# HINKLEY POINT C PERMIT VARIATION

EPR/HP3228XT/V004

**Technical Brief: TB006**

**Low Velocity Side Entry Intake Design; effect of intake intercept area.**

Figure 1. Interpretation of HPB intake configuration.

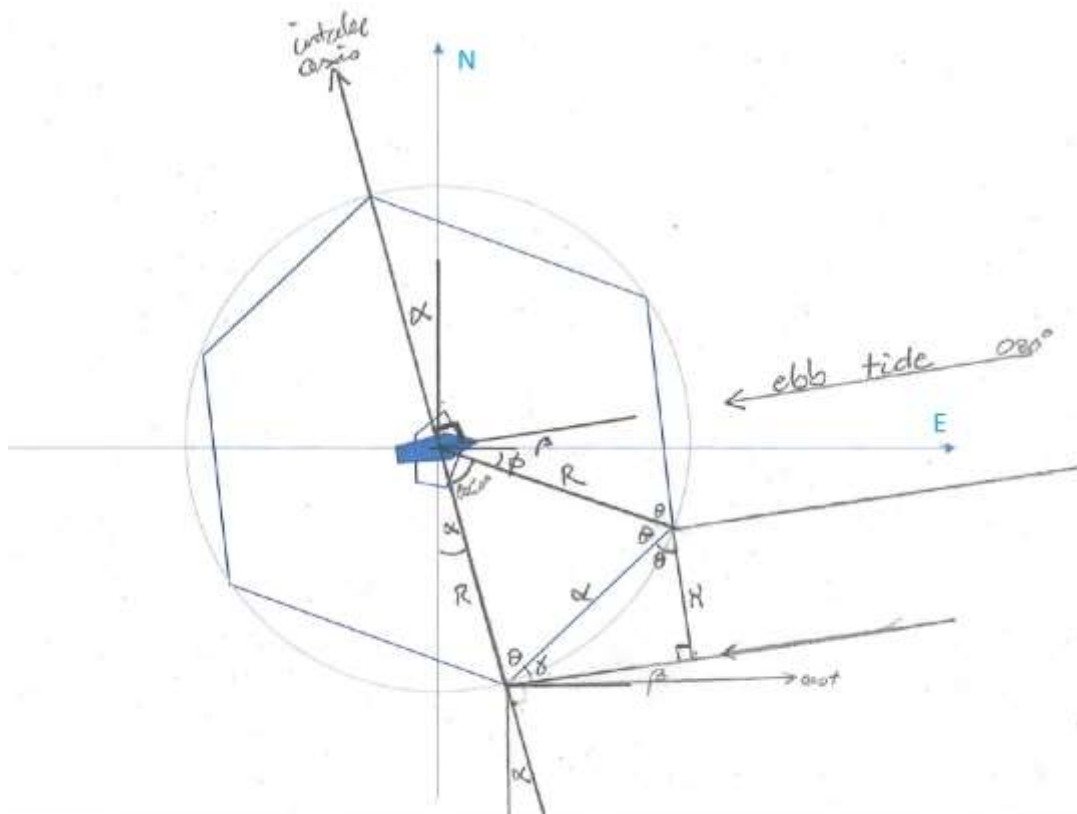
It is not easy to calculate the effective area of the HPB intake, because the intake is not fully submerged at all states of the tide. TR456 Ed2 derived a tidal-average height, and multiplied by the cross-section (projected) width. While this approach seems reasonable, we derived a different value for this width. We cannot verify the height.

TR456 Ed2 contains a text description of the HPB intake configuration, in Appendix J, and an indicative sketch at Figure 2. Our interpretation of this layout is shown in the sketch below (Figure 1):

- the intake axis runs at  $350^\circ$  - angle  $\alpha = 10^\circ$
- the ebb tide direction is  $080^\circ$  - angle  $\beta = 10^\circ$
- because of equilateral triangles (regular hexagon), each angle marked  $\theta = 60^\circ$ .

The target width (cross-section across the ebb tide) is  $= R \sin \gamma$ , where  $\gamma$  is the angle between the HPB intake face and the ebb tide direction. With  $\theta = 60^\circ$ ,  $\gamma = 30^\circ + \alpha - \beta$ , and with  $\alpha = \beta = 10^\circ$ ,  $\gamma = 30^\circ$ ; thus  $x = R \sin 30^\circ = 0.5 R$ .

(This contrasts with the statement in TR456 Ed2 that  $x = R \sin(60^\circ - \alpha - \beta) = R \sin 40^\circ = 0.64 R$ .)

Figure 2. Seabed current rose at HPC intake location.

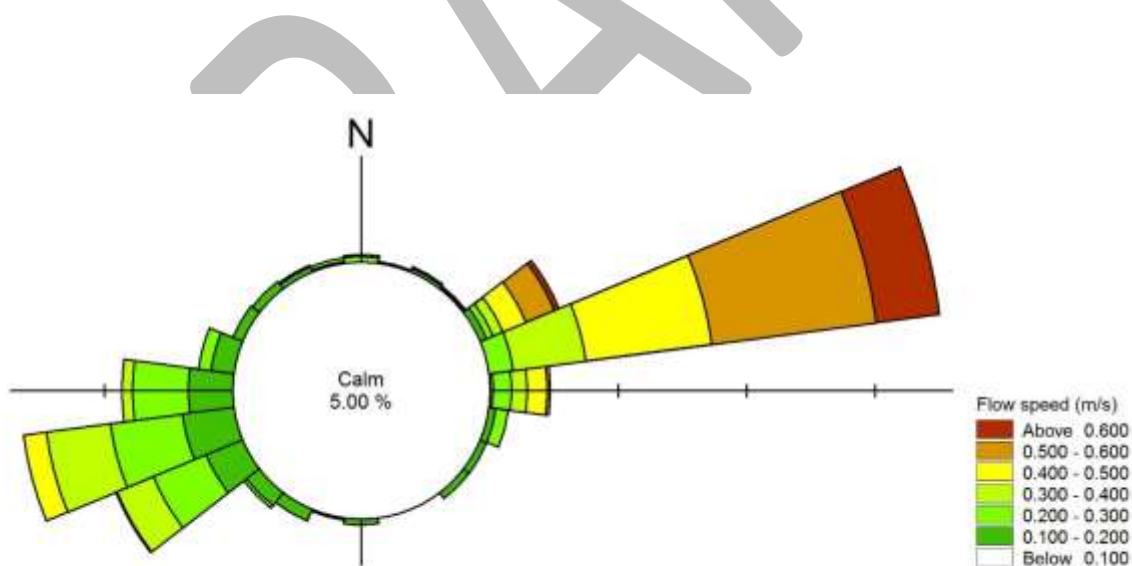
We estimated the effective area of the HPC intake, using seabed tidal current data provided by the applicant from the GETM model. The model provided 30 days – two full spring-neap tidal cycles – from which we calculated a current rose (Figure 2). This grouped the velocity data into bins of speed and direction, to simplify the subsequent calculations. Using the current rose, we established the approach velocity (speed and direction) at different times, and an intersection projected area. Slack water conditions were treated differently, as a special case (see below). We averaged the intake volume over the full model period and derived an average intersection area.

Figure 3. Figure A5 from CW1 P1 paper.

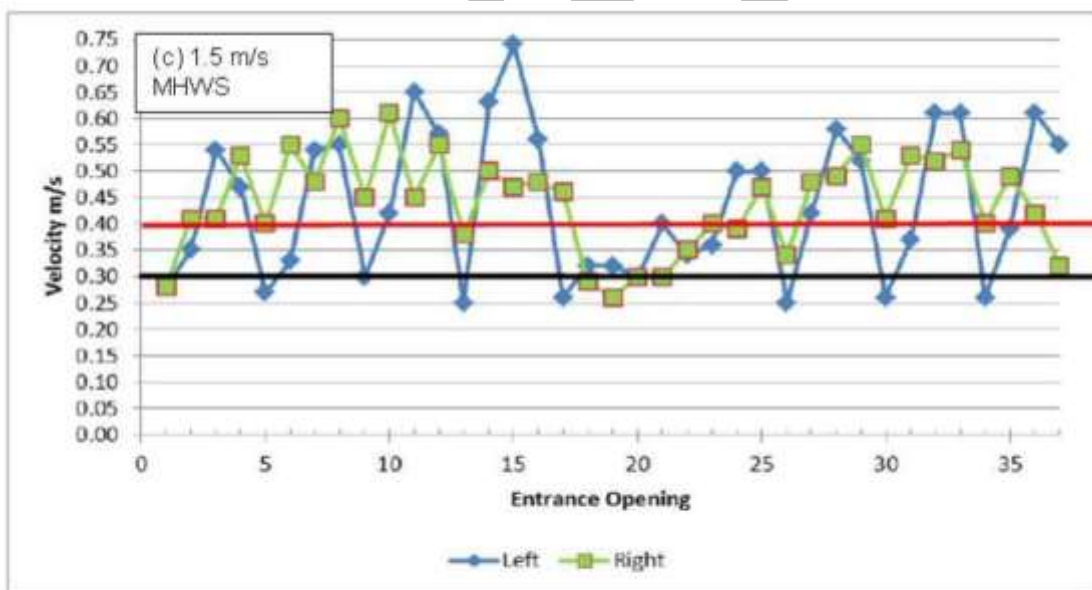
Figure 3 (reproduced from CW1 P1) shows that at peak tidal flow, the escape velocity needed by fish to avoid entry to the intake head is generally above  $0.4\text{ms}^{-1}$  along both sides of the intake head. The Environment Agency Best Practice Guide (2005) recommends that the velocity at intake screens be kept to at or below  $0.3\text{ms}^{-1}$  in order to allow fish to escape given a cue to do so. From EA (2005), “*swimming performance is strongly influenced by the species and the length of the fish and to a lesser extent by water temperature. The required criterion is that the fish approaching an intake should be able to swim fast enough and for long enough to ensure their escape via the bywash or any other route provided to return them to the main river flow. Whether this is achieved by using sustained (aerobic) or burst (anaerobic) swimming will depend on conditions: burst swimming will usually require high motivation by the fish, e.g. a startle response that might be caused by a strong stimulus (e.g. electric shock, sound pulse or strobe light flash).*”

According to CW1 P1, the HPC LVSE intake heads are predicted to achieve this criterion 66% of the time. Although this is not entirely compliant with the  $0.3 \text{ m s}^{-1}$  criterion recommended by the Environment Agency, the CW1 P1 document concludes that the HPC intake heads should still be considered acceptable as they achieve  $0.4 \text{ m s}^{-1}$  for 86% of the time and  $0.5 \text{ m s}^{-1}$  for 95% of the time, which are considered to be protective of fish species likely to be entrapped.
